Proposed Code Modifications

This document created by the Florida Department of Business and Professional Regulation -
850-487-1824

TAC: Structural

FIGURE R610.5(1)

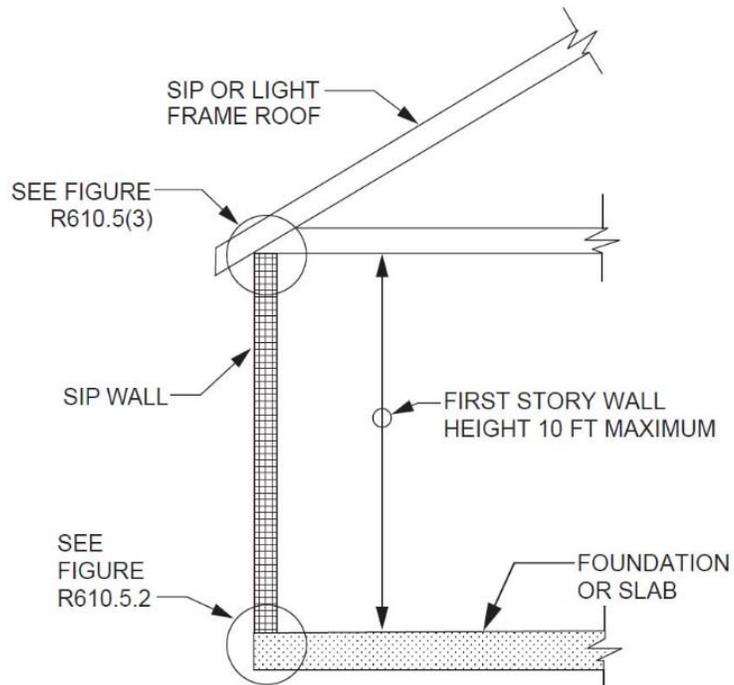
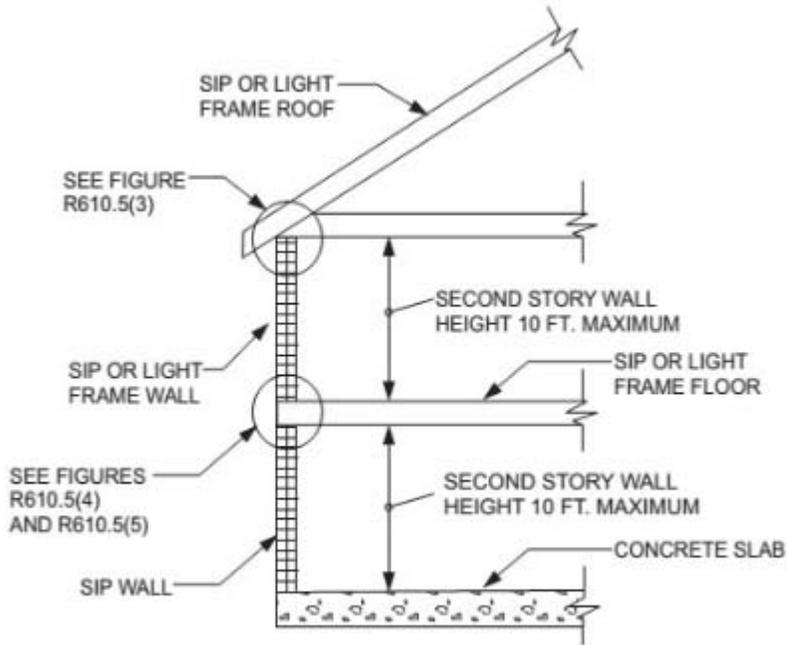
Replace the figure above by the figure below

FIGURE R610.5(2)

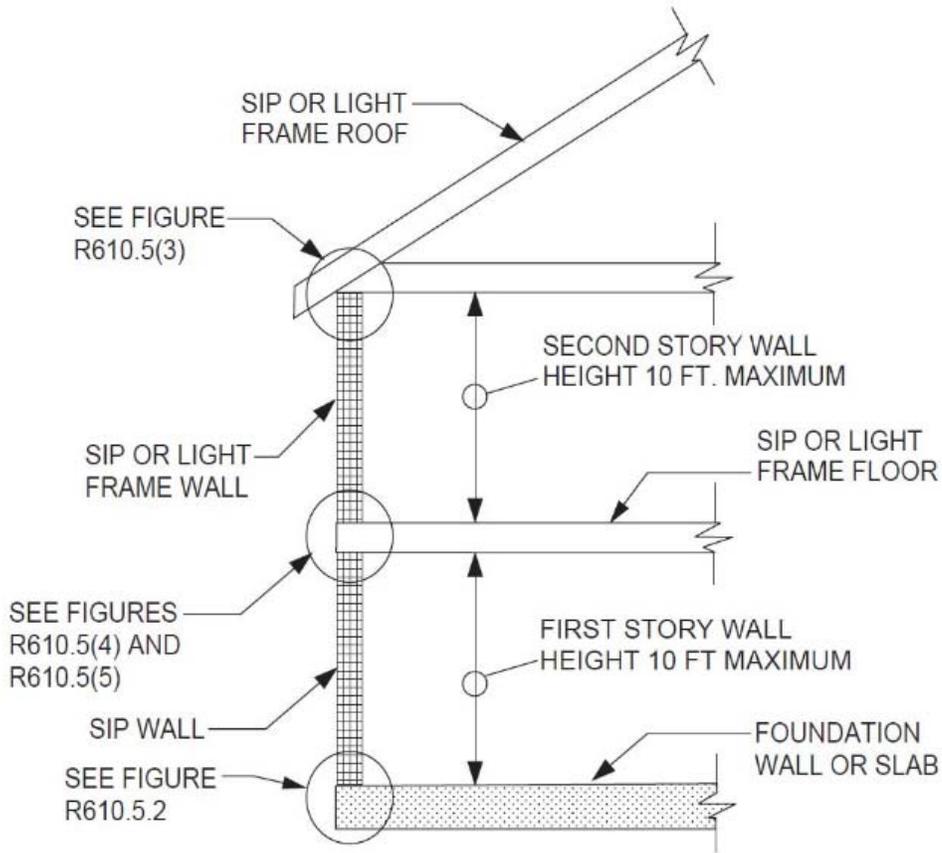
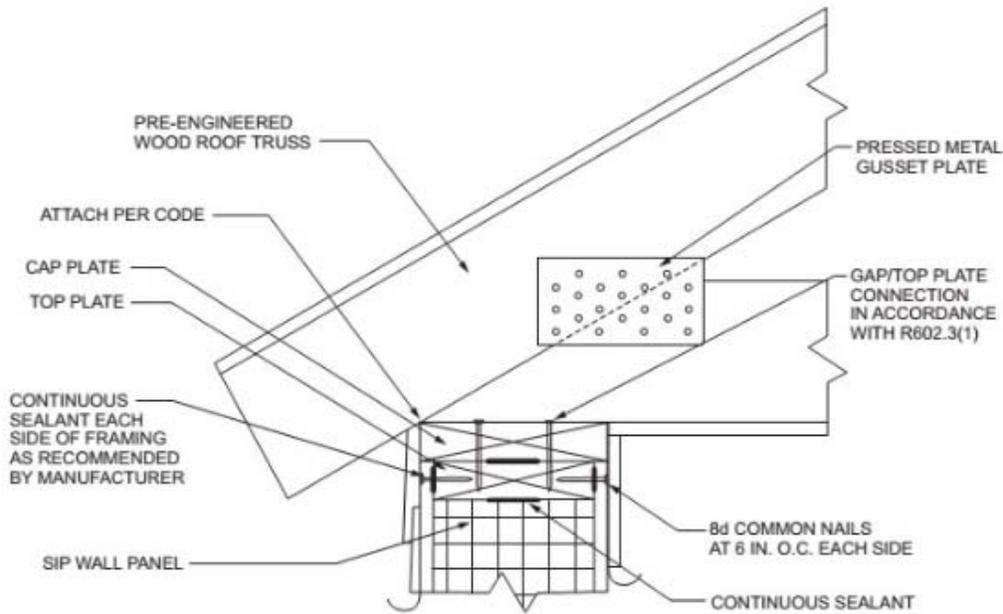
Replace the figure above by the figure below

FIGURE R610.5(3)
TRUSSED ROOF TO TOP PLATE CONNECTION

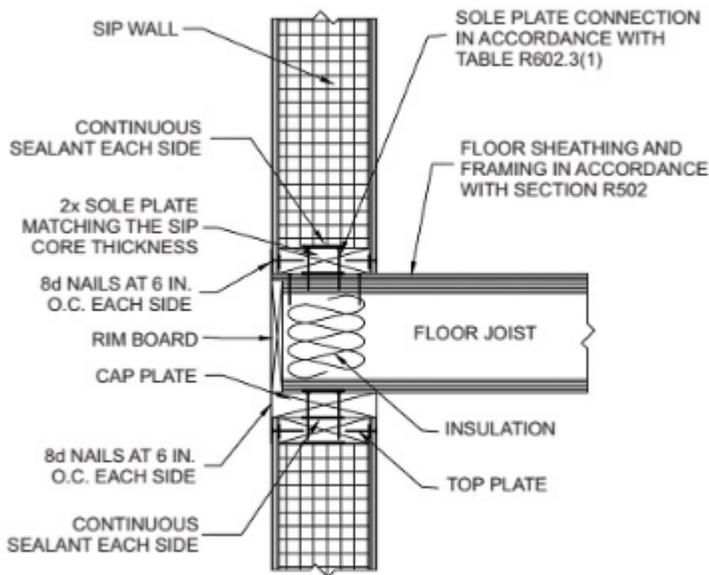
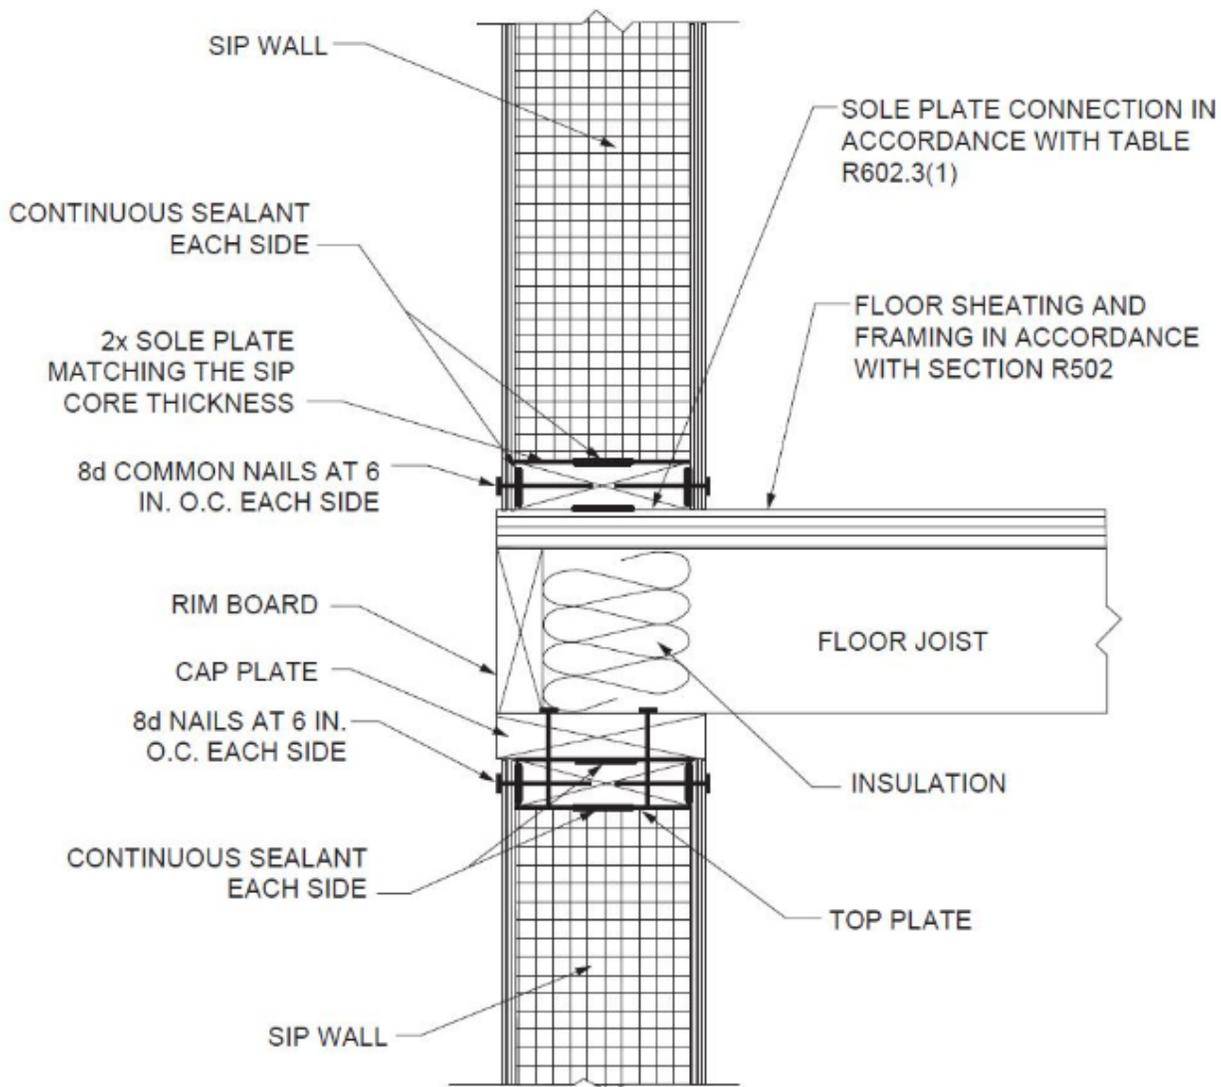
Replace the figure above by the figure below

FIGURE R610.5.1

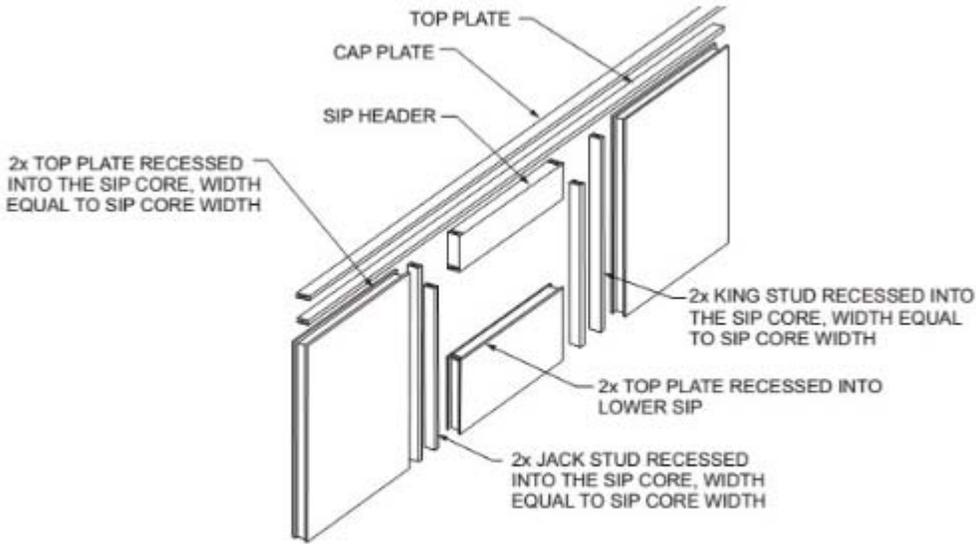
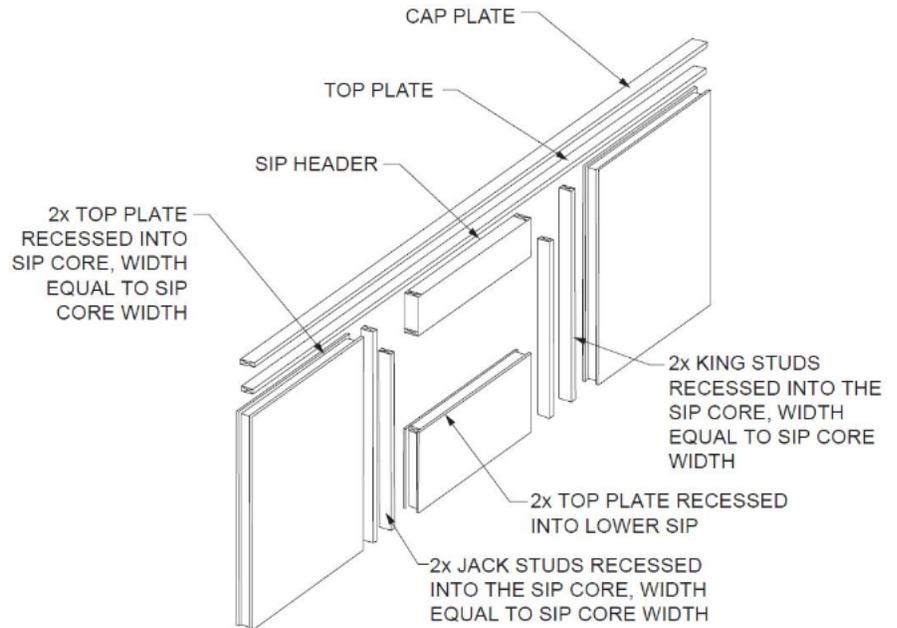
Replace the figure above by the figure below

SIP walls shall be capped with a double top plate installed to provide overlapping at corner, intersections and splines in accordance with Figure R610.5.1. The double top plates shall be made up of a single 2 by top plate having a width equal to the width of the panel core, and shall be recessed into the SIP below. Over this top plate a cap plate shall be placed. The cap plate width shall match the SIP thickness and overlap the facers on both sides of the panel. End joints in top plates shall be offset not less than 24 inches (610 mm).

Corner framing of SIP walls shall be constructed in accordance with Figure R610.9.

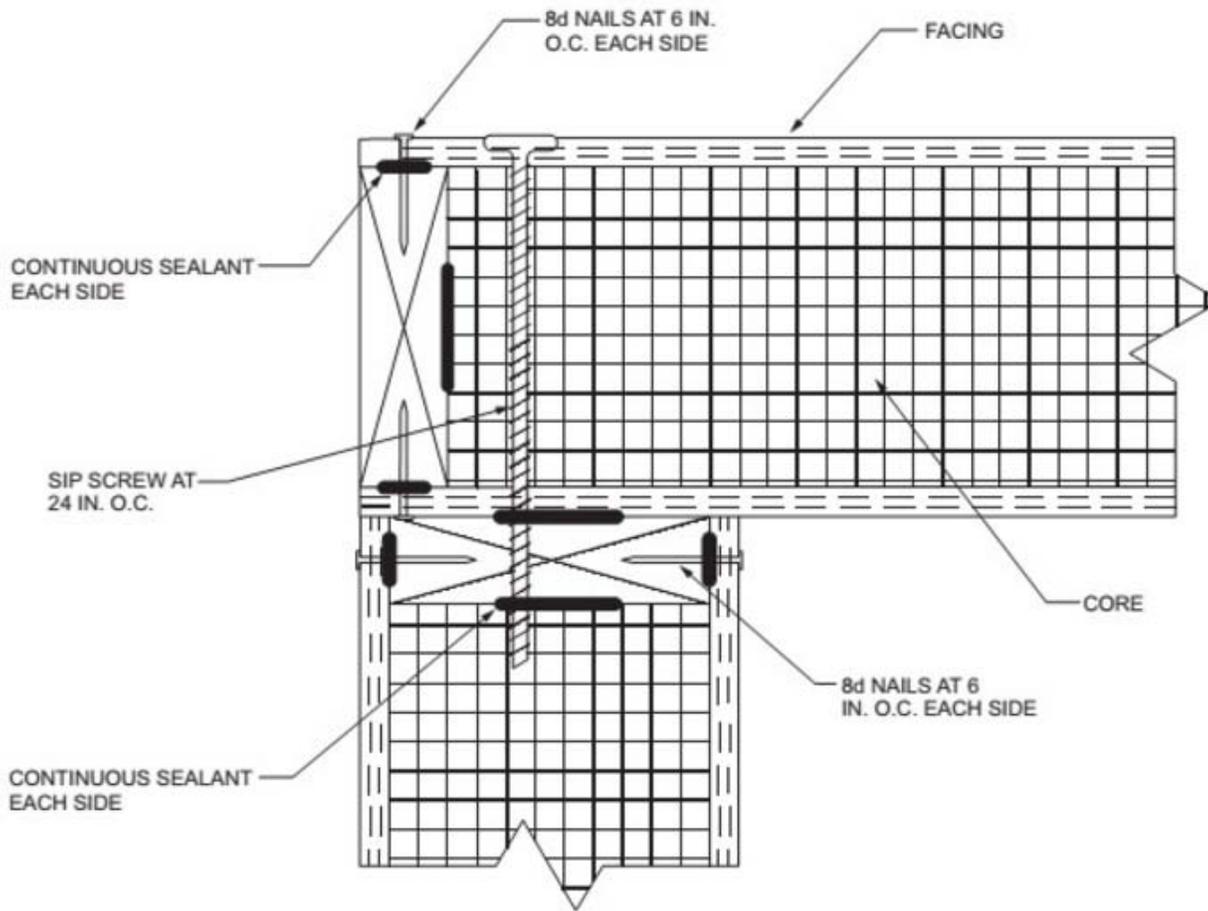
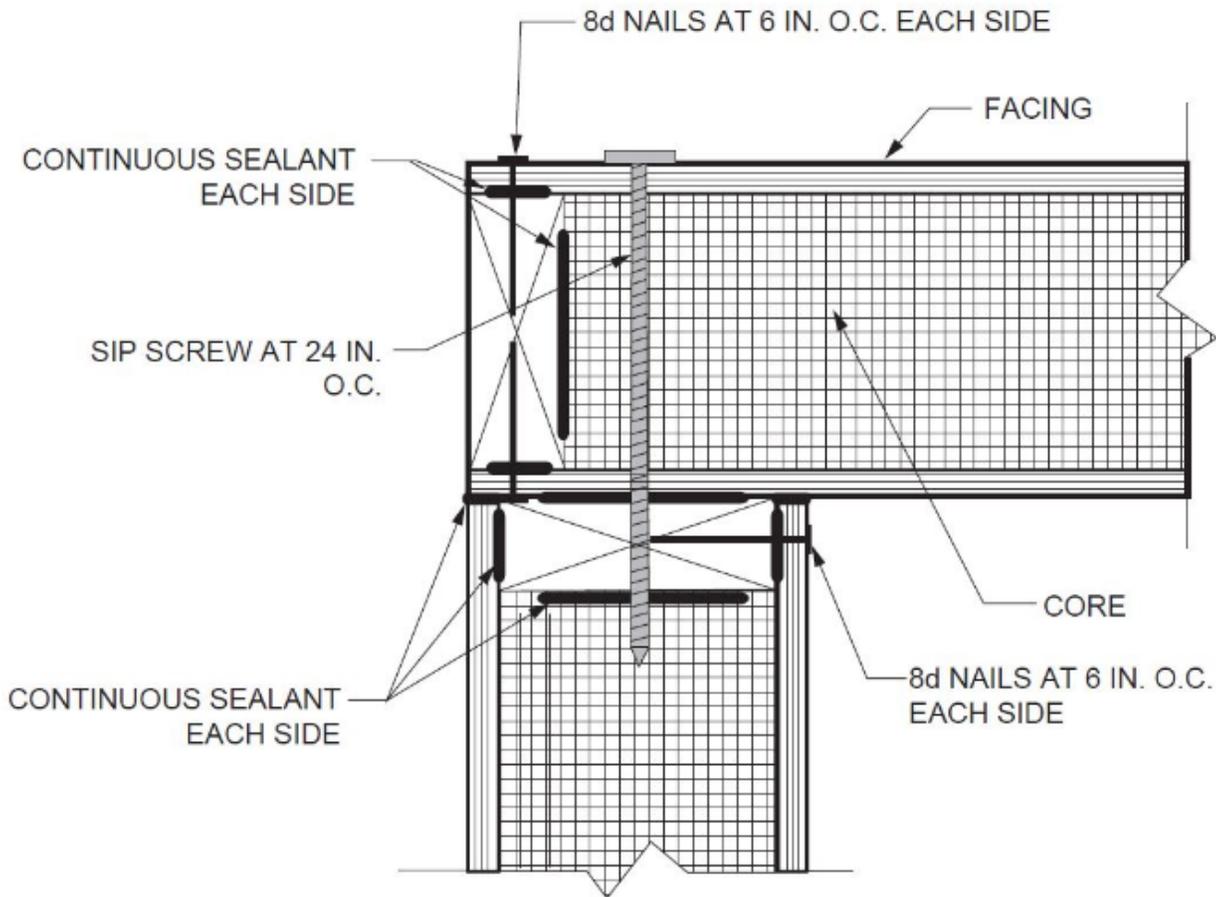
[Replace the figure above by the figure below](#)

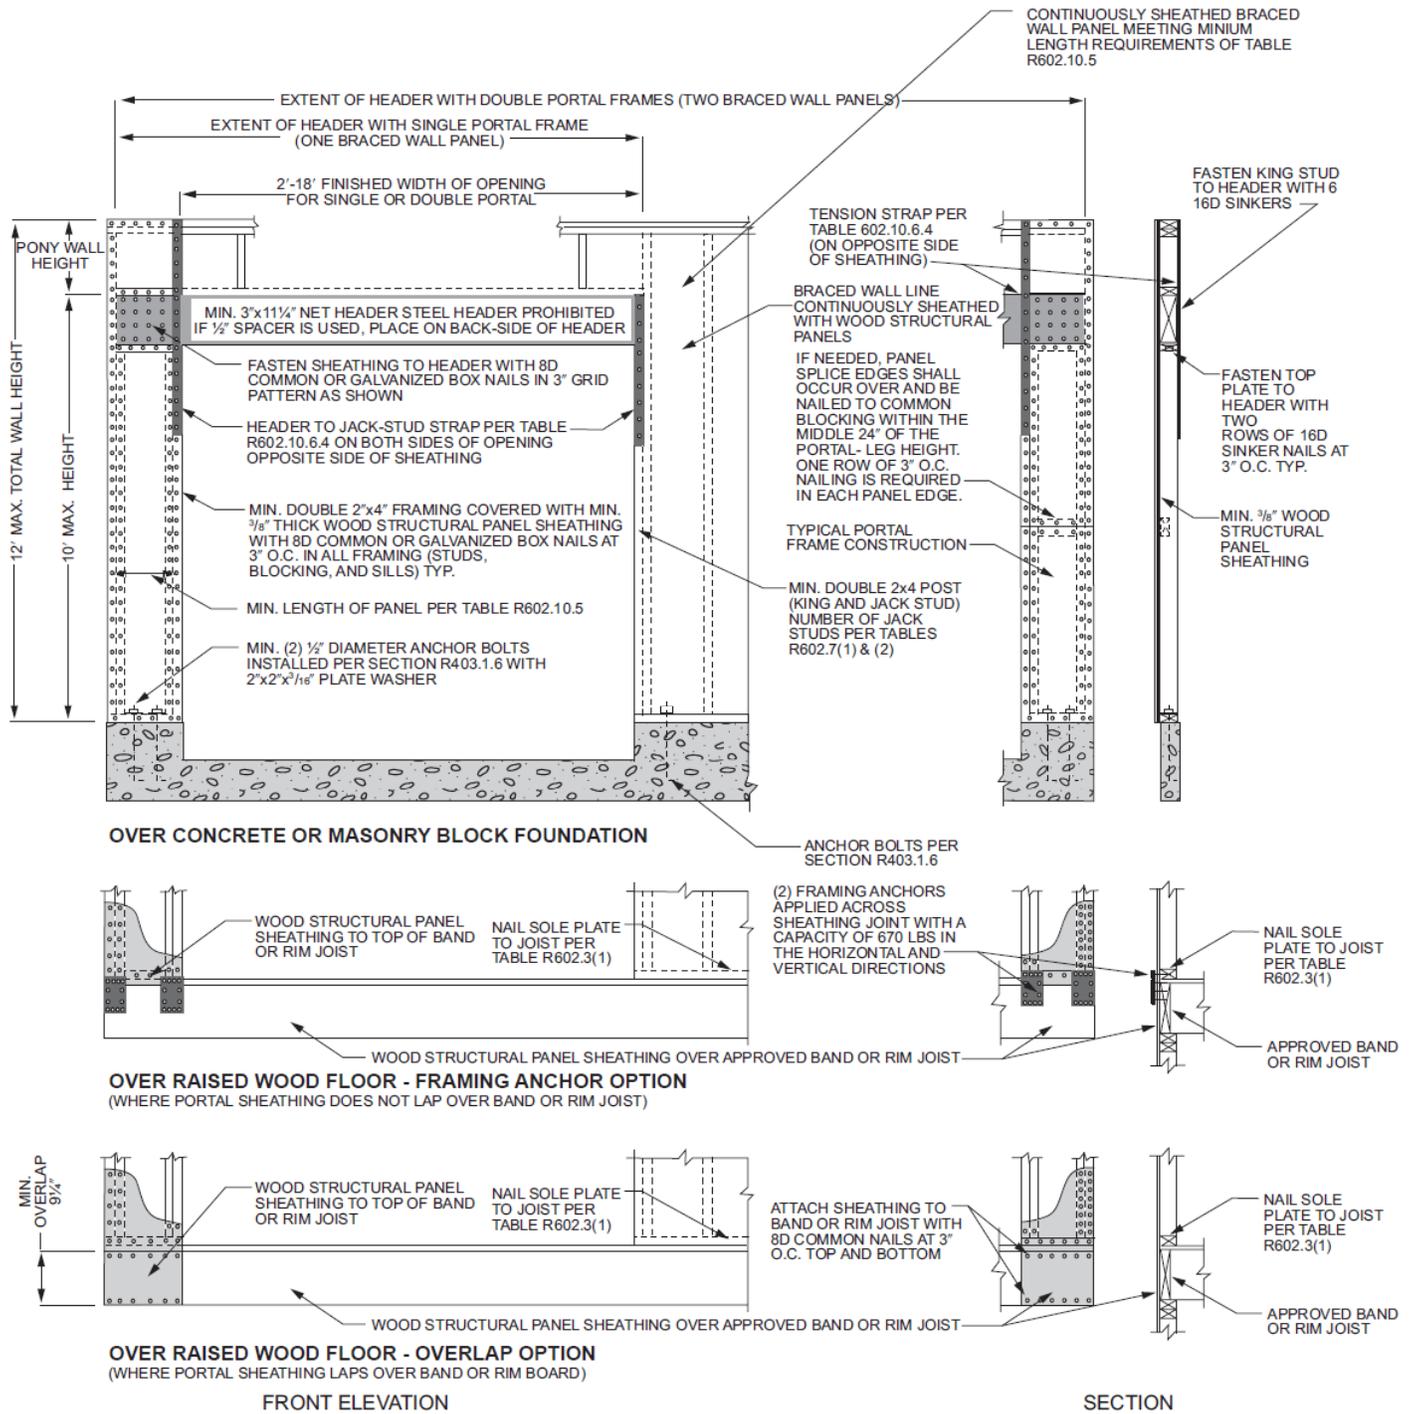
A clean copy of the revised figure is shown below from the 2018 IRC (except that the WSP sheathing should remain unchanged at 7/16").
